Response to Submissions Report

SSD-9575-Mod-2: Modification to New Tweed Valley Hospital

Prepared for: Health Infrastructure
© GeoLINK, 2020

Plate 5.1 Approved Retaining Wall Layout

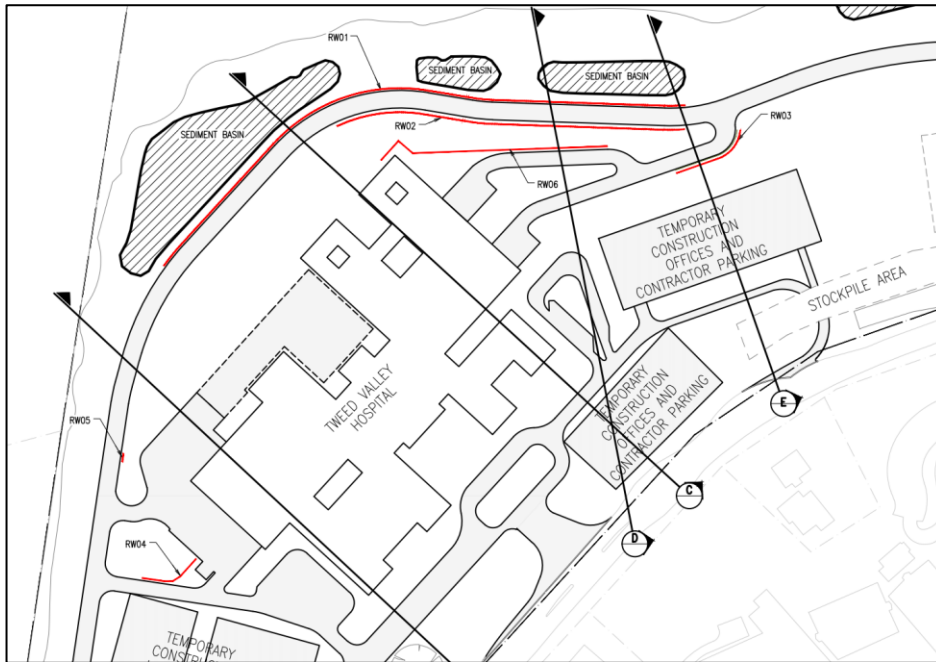
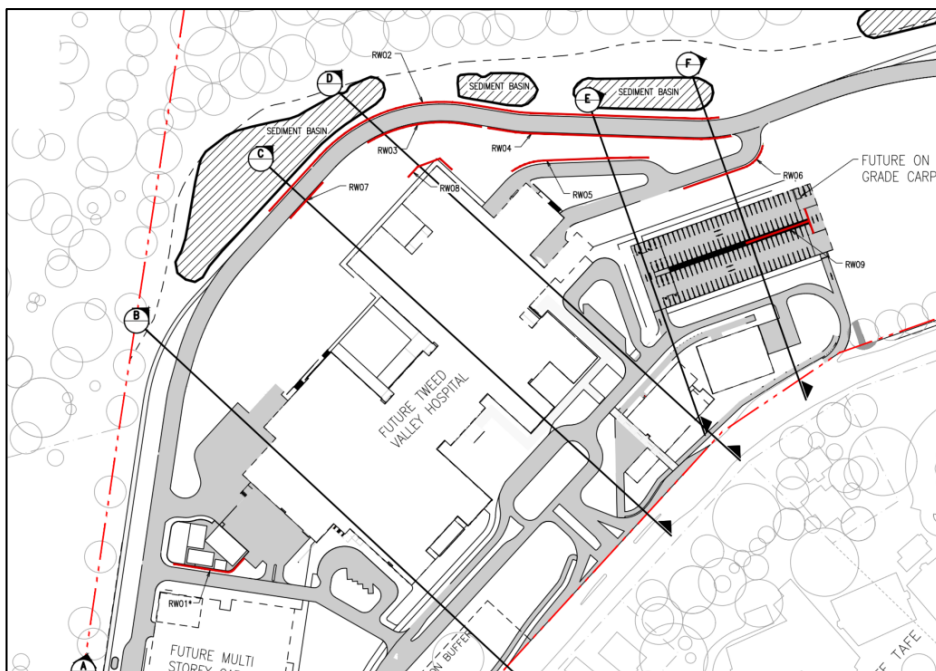
<p>The submitted plans indicate that the amended building envelope for the hospital and the car park would result in modifications to the volume of cut and fill that was previously approved under the Stage 1 Works.</p> <p>Having regard to the above, an amended plan should be provided that identifies the modifications to the cut and fill volumes and the need for any further retaining walls (or variation to the heights of the retaining walls) within the site.</p>	<p>Section 5.1.1 provides an outline and assessment of the proposed cut/fill and retaining wall changes. In summary, the alterations to the building envelope and other modifications results in the following adjusted bulk earthworks quantity estimates and retaining wall lengths (as identified in the civil plans at Appendix B):</p> <ul style="list-style-type: none"> ■ Total cut volume: 71,730 m³. ■ Total fill/reuse of won material on-site: 59,600 m³. ■ Excess material/spoil for removal from site: 12,130 m³. ■ Total combined length of retaining walls has decreased from 654 m to 642 m.

As outlined by DPIE in their correspondence and addressed in **Section 4.4**, the submitted modification plans indicate that the amended building envelope for the hospital and the car park, along with the overall on-site parking reconfiguration, would result in modifications to the volume of cut and fill that was previously approved under the SSD 9575 Stage 1 Works. DPIE identified that changes to retaining walls may also be required. DPIE have therefore requested amended plans that identifies the modifications to the cut and fill volumes and the need for any further retaining wall variations.

The individual retaining wall changes can be seen in **Plates 5.1** and **5.2** and are provided in **Table 5.1** below for comparison (the text indicates approved retaining wall detail compared to modified/revised wall detail in red text).

<i>Revised Wall Ref - note wall reference numbers have changed between the approved and revised plan.</i>	<i>Original SSD1 Wall Ref</i>	<i>Approved Approx. Length</i>	<i>Modified Approx. Length</i>	<i>Approved Probable Max Height</i>	<i>Modified Probable Max Height</i>
RW01 *now forms part of the building retaining wall (not part of the civil design)	RW04	30 m	*	Up to 3.0 m	
RW02	RW01	290 m	250 m	Up to 3.4 m	3.4 m
RW03	RW02 (now broken into two walls: RW03 and 04)	170 m	60 m	Up to 2.5 m	1.5 m
RW04			124 m (RW03 above and RW04 combined = 184 m)		3.4 m
RW05	RW06 (now broken into two walls: RW05 and 08)	120 m	67m (RW05 and RW08 below combined = 95 m)	Up to 1.5 m	2.2 m
RW06	RW03	40 m	48 m	Up to 2.4 m	3.0 m
RW07 (new wall)	N/A	-	25 m	-	1.6 m
RW08	RW06 (now broken into two walls: RW05 and 08)	120 m	28 m (RW05 above and RW08 combined = 95 m)	Up to 1.5 m	3.4 m
RW09 (new wall)	N/A	-	40 m	-	2.5 m
N/A	RW05 – Original RW05 wall deleted (RW05 has been renumbered as a different wall – see plan)	4.0 m	-	Up to 0.5 m	-

As shown in the above table, the total combined length of proposed retaining walls has reduced from 654 m to 642 m. With regard to the Stage 1 Works approval and proposed changes, the determining authority included a specific condition limiting the height of retaining walls on the site to a maximum of 3.4 m. The proposed changes to the retaining walls are either under or do not exceed this height requirement.
